**TENNESSEE VALLEY AUTHORITY
SEQUOYAH NUCLEAR PLANT
UNITS 1 AND 2**

**ANP-3053(NP), Revision 4, Sequoyah HTP Fuel Transition –
NRC RAIs and Responses, June 2012
(Non-Proprietary Version)**

Sequoyah HTP Fuel Transition –
NRC RAIs and Responses

Figure 5: Sequoyah Core Safety Limit Comparison for Advanced W17 HTP Transition

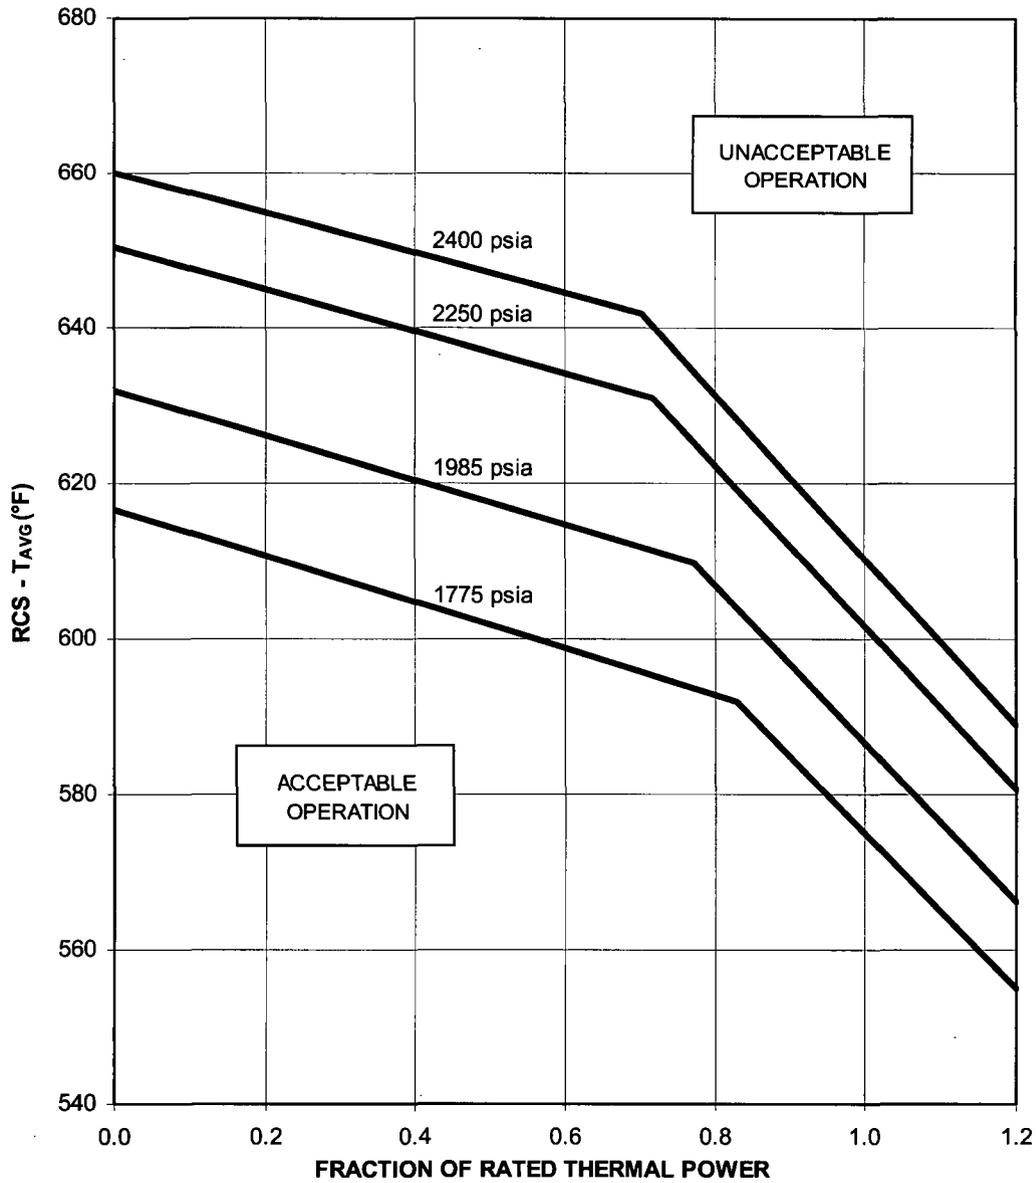
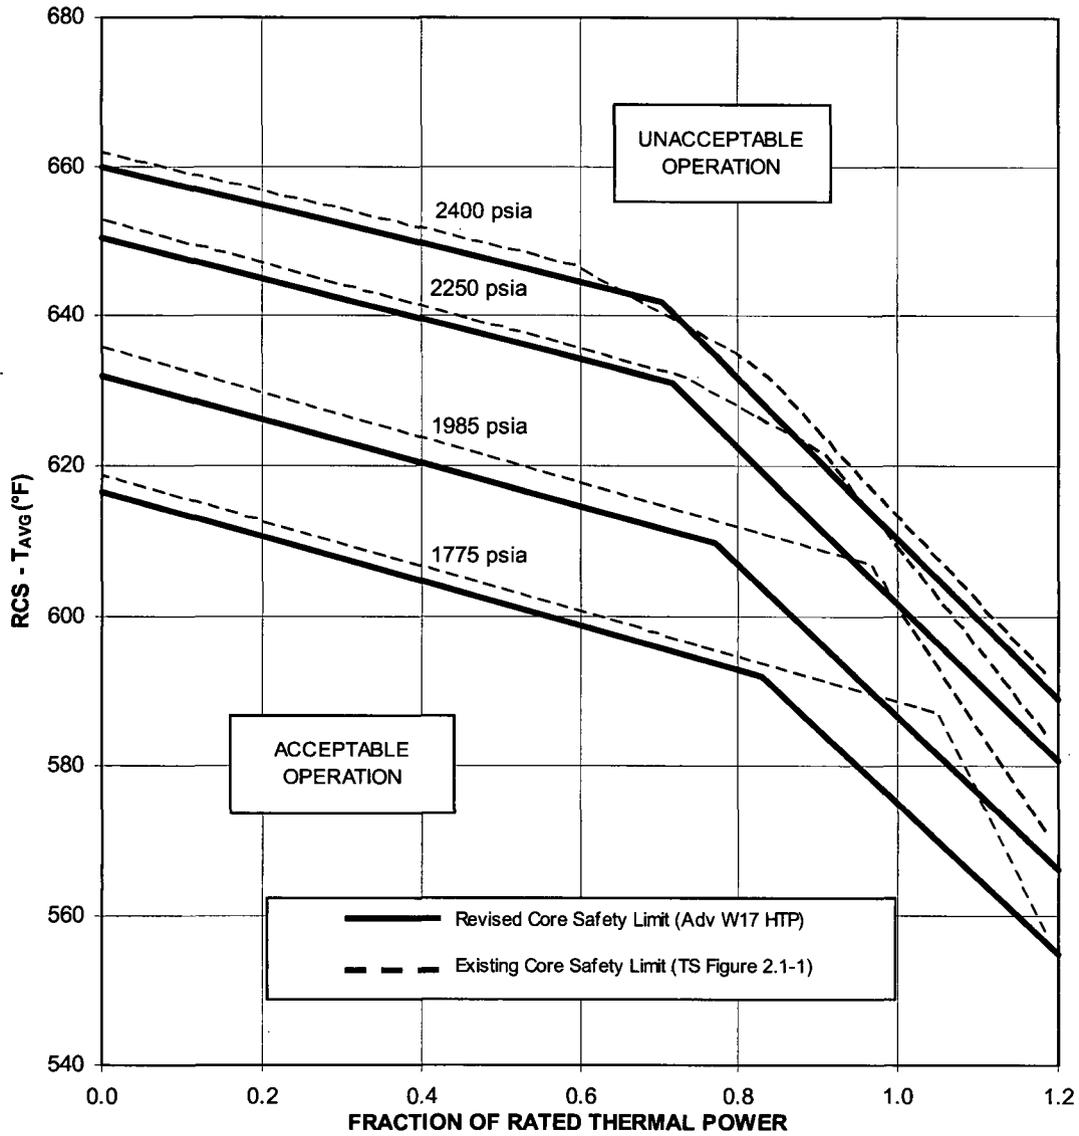
Provide a detailed description with respect to the applicability of all the approved methodologies listed in the proposed TS 6.9.1.14.a to the AREVA Advanced W17 HTP fuel design.

As a result of these changes, the core safety limit lines shown in Figure 2.1-1 of the SQN Units 1 and 2 Technical Specifications will be modified to represent the protected OT Δ T trip limit lines and are shown in Figure 4 below.

In addition, Figure 4-1 of ANP-2986(P) Revision 3 is replaced by Figure 5, below, which provides a comparison between the CSL lines consistent with the protected OT Δ T limit lines, with a flow rate of 378,400 gpm, and the current existing Sequoyah TS CSL lines. It is noted that the pressures are not identical for the comparison between the Adv. W17 HTP line (at 1985 psia) and the Sequoyah TS CSL line (at 2000 psia).

Similarly, Figure 1 of the LAR Enclosure should be replaced with Figure 5 below (it should be noted that Figure 1 of the Enclosure is mislabeled, as it refers to Current

Mark-BW versus Proposed Adv. W17 HTP Fuel; the figure is actually a comparison of the existing Technical Specification Figure 2.1-1 to the Proposed Adv. W17 HTP Fuel and does not present the Mark-BW-specific core safety limit lines).

The revised CSL lines generated for the Adv. W17 HTP fuel design at the higher reactor coolant flow rate were evaluated against the Mark-BW CSL lines at the current reactor coolant flow rate, and it was shown that the CSL lines shown in Figure 4 are applicable to both fuel designs resident in the SQN Units 1 and 2 cores. Therefore, Figure 4 is applicable for use in the SQN Units 1 and 2 Technical Specifications.

Figure 21: Expected Advanced W17 HTP Transition Core Penalties (Maximum Calculated Penalties)

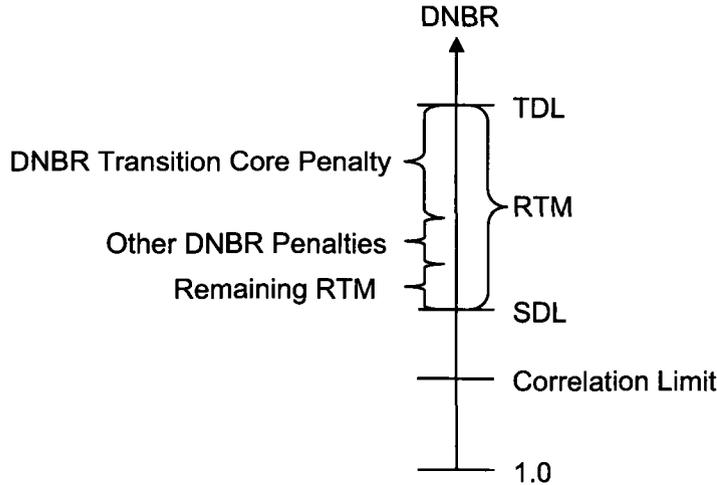
The June 17, 2011, submittal stated that the thermal hydraulic analysis indicates that the transition from a full core of Mark-BW fuel to a full core of Advanced W17 HTP fuel will result in a small increase in bypass flow and a small decrease in the RCS loop flow due to the higher pressure drop of the Advanced W17 HTP fuel. It also stated that the combined effect of the fuel transition and the steam generator replacement is a small net increase in RCS loop flow. Based on the reason above, TVA requested to revise the design flow rate shown in Table 2.2-1 and Figure 3.2-1. Please provide: (1) the rationale for a small net increase in RCS loop flow due to the combined effect of the fuel transition and the steam generator replacement; (2) how to obtain or to generate the data for design flow rate of 91,400 GPM in Table 2.2-1 and total RCS flow rate of 378,400 GPM at 100% Thermal Power Fraction (TPF) and 359,480 GPM at 90% TPF in Figure 3.2-1, respectively; and (3) justification for proposed 5% RCS flow rate increase.

calculated each cycle for each fuel type present within the core. A representative diagram illustrating RTM (including a transition core penalty) is given below in Figure 20.

This response describes how the DNBR transition core penalty (TCP) was derived for Advanced W17 HTP fuel. As mentioned below, no DNBR TCP is necessary for the resident Mark-BW fuel.

For each Advanced W17 HTP transition cycle, the appropriate DNBR TCP is determined based on the number of Advanced W17 HTP assemblies in the core. Alternatively, the penalty may be calculated for a specific cycle by repeating the analysis described above with the actual loading pattern for that Advanced W17 HTP transition cycle.

particular transition cycle. The amount of RTM expected for the transition cycles is approximately [] of the TDL. As can be seen in Figure 21, the expected DNBR TCP for a core with 89 Advanced W17 HTP assemblies (typical for a first transition cycle) is approximately []. This indicates that there is sufficient RTM to account for mixed core effects on DNB. It will be verified on a cycle-specific basis that the RTM can accommodate the DNBR TCP and any other DNBR penalties required for DNBR-related concerns.
